## **Proposal for Supplement 7 to the 01 series of amendments to Regulation No. 112 (Headlamps emitting an asymmetrical passing-beam)**

### **Submitted by the Working Party on Lighting and Light-Signalling\***

## Supplement 7 to the 01 series of amendments to Regulation No. 112 (Headlamps emitting an asymmetrical passing-beam)

Figure 9

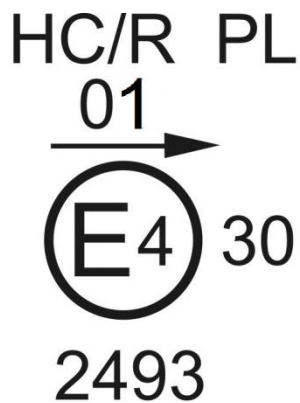
*Annex 2, figures 5 to 10, amend to read:*

Figure 9: Class B in respect to both the passing-beam and driving-beam and designed for left-hand traffic only.

Figure 10

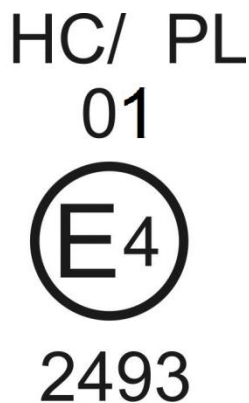
Figure 10: Class B in respect to the passing-beam only and designed for right-hand traffic only.

"Figure B  
Passing-beam for right-hand traffic

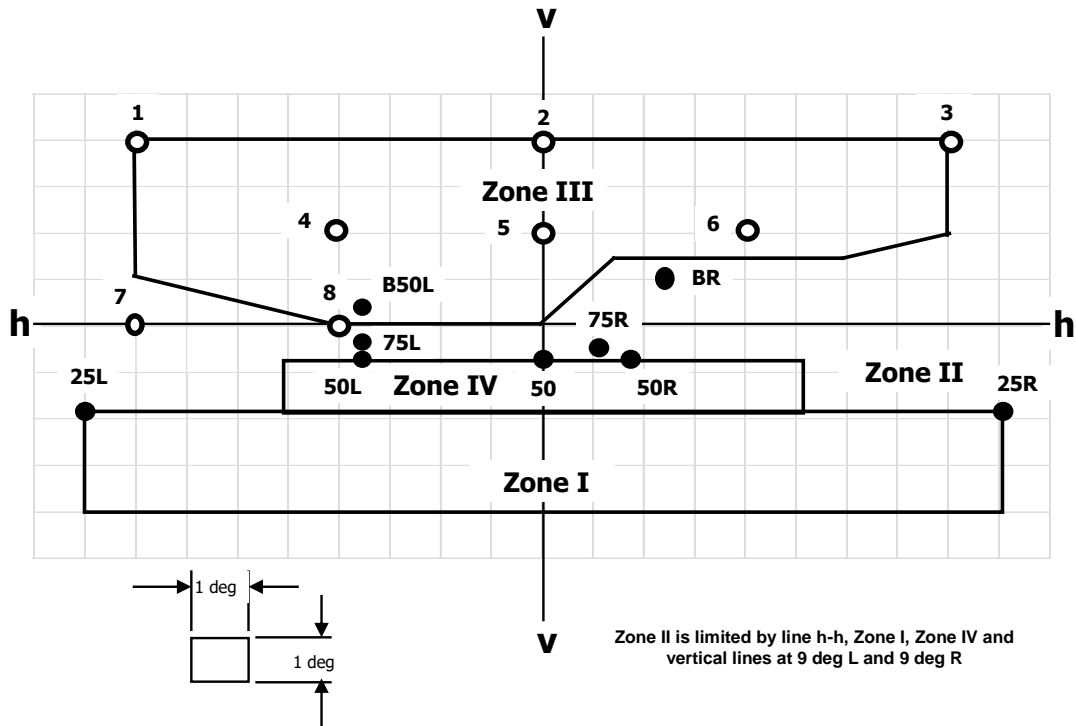
*Figure B, amend to read:*

h-h = horizontal plane , v-v = vertical plane passing through the optical axis of the headlamp  
The test point locations for left-hand traffic are mirrored about the VV line."
